REVIEW OF PROPOSED RESPONSE TO
EPA ENFORCEMENT ORDER NO. 83-01.

ISSUED TO
MONTROSE CHEMICAL CORPORATION
TORRANCE, CALIFORNIA

November 1983

Prepared by
METCALF & EDDY, INC.
50 Staniford Street
Boston, Massachusetts 02114

STAKING PLAN & DETAILS
TORRANCE PROJECT

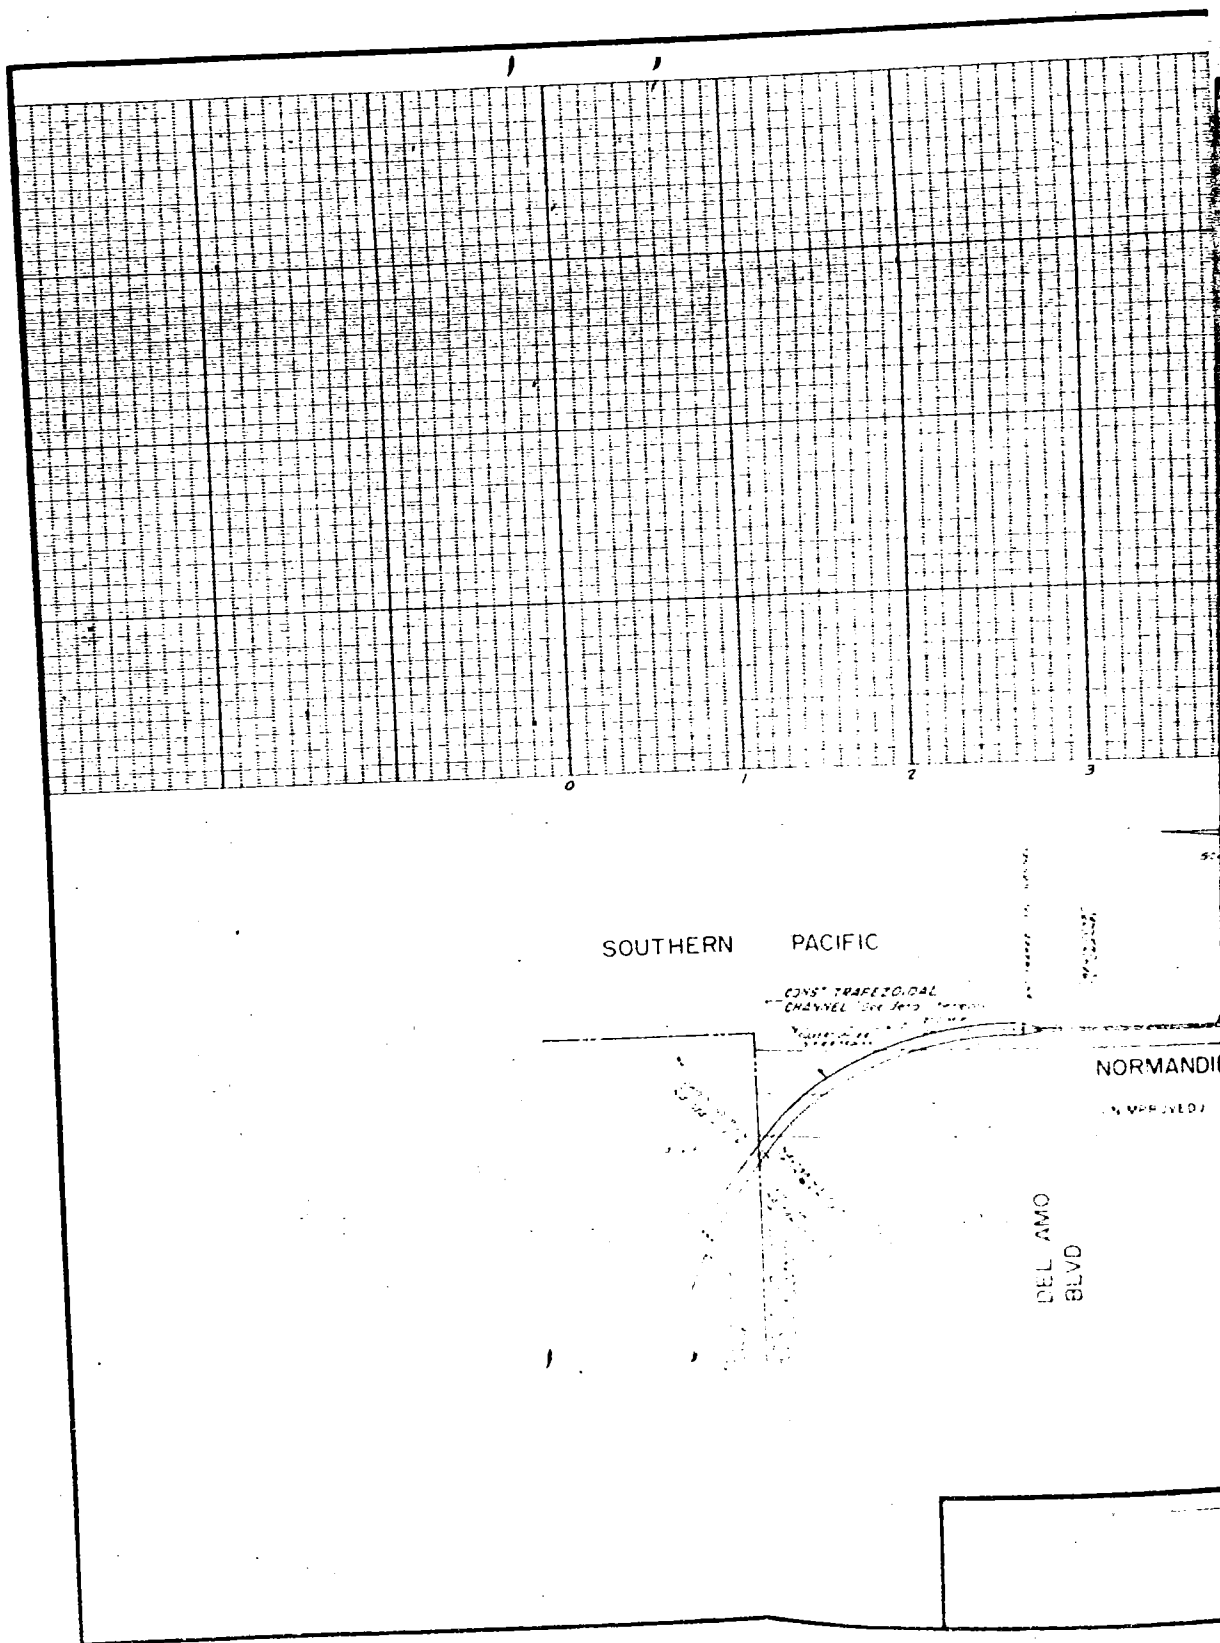
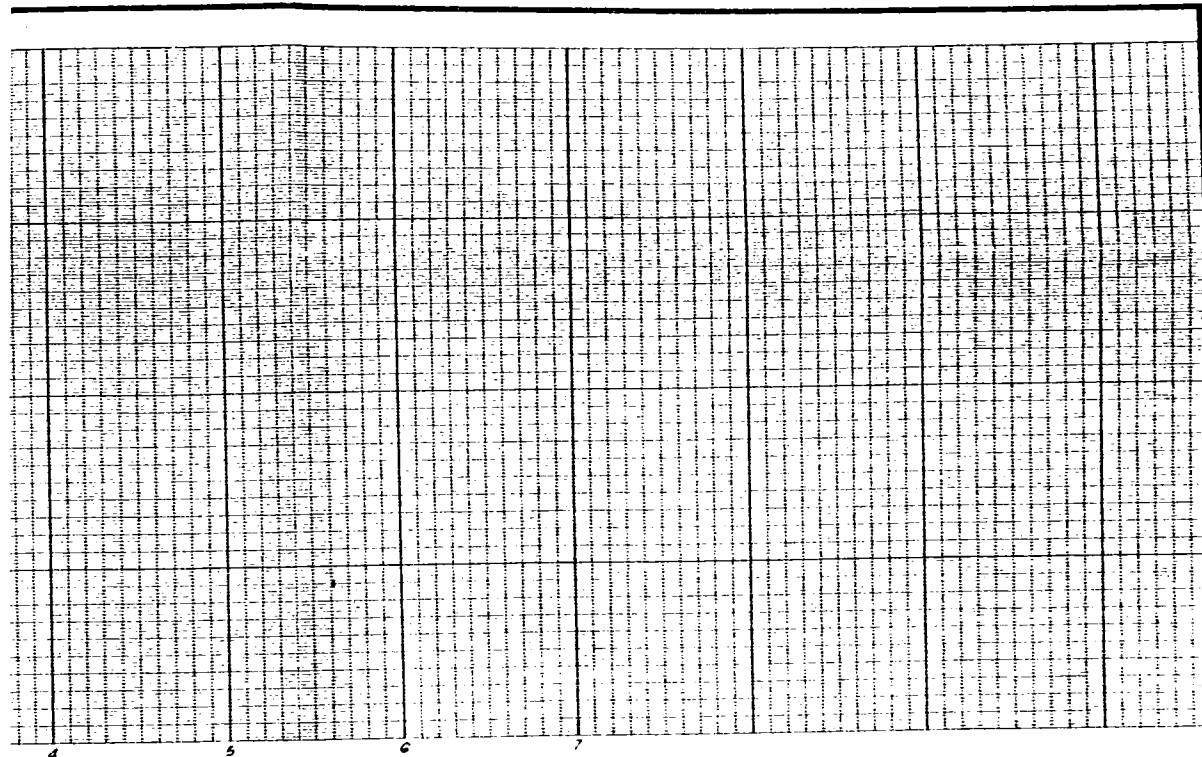
Curb design as shown in the construction plans does not prevent stormwater runoff from other properties from entering the Montrose site. The 6-inch curb is more than 2 feet below ground surface at the property line at many places, and some of these contributory areas are unpaved. Curb/paving design should be modified to accomplish the intended purpose.

Plans show more than 2,000 feet of high pressure water lines on the property, crossing areas containing DDT concentration in the 1000s of ppm. Any high pressure liquid lines should be installed in concrete box culverts to prevent massive DDT discharges in the event of a break.

DETAIL
TRAPEZOID CHANNEL

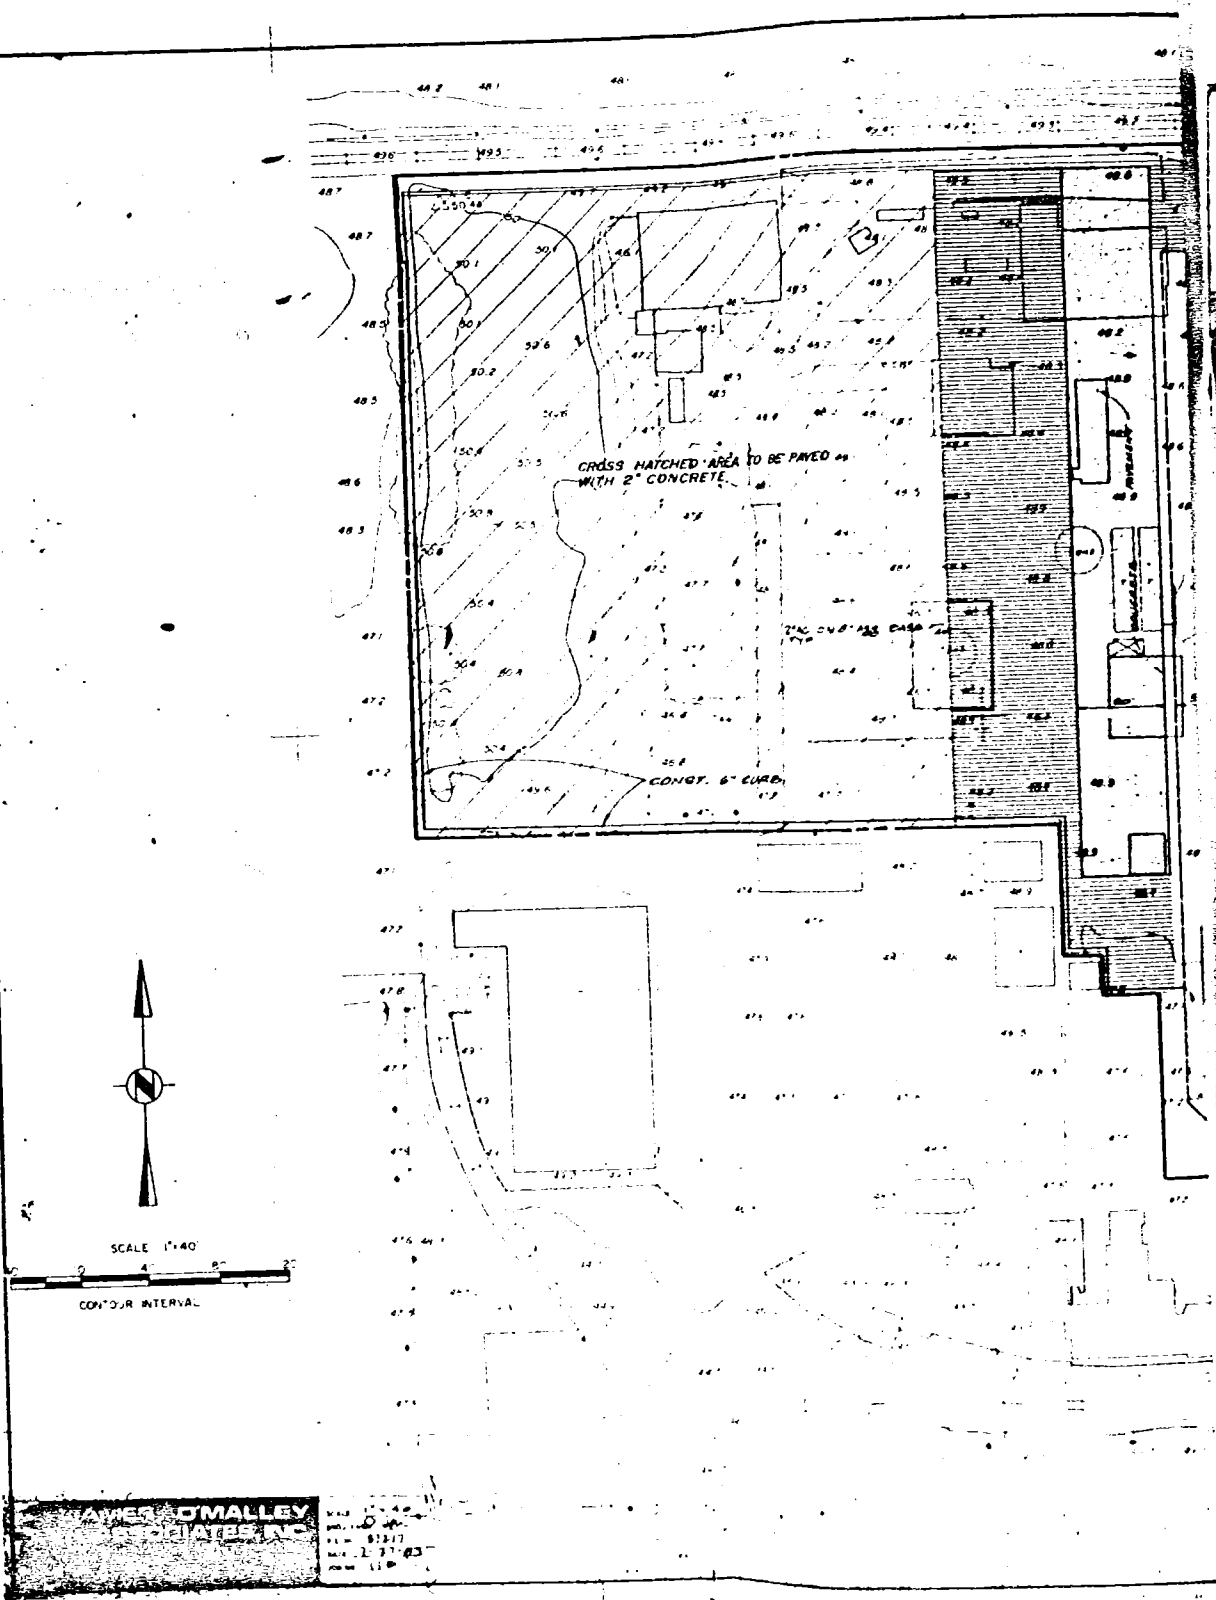
Design calculations show that the trapezoidal channel conveying runoff from Montrose to near the Farmer Brothers catchbasin is sized only for a 25-year storm. All stormwater management structures, including curbing around the site, should be sized for the 100-year storm.
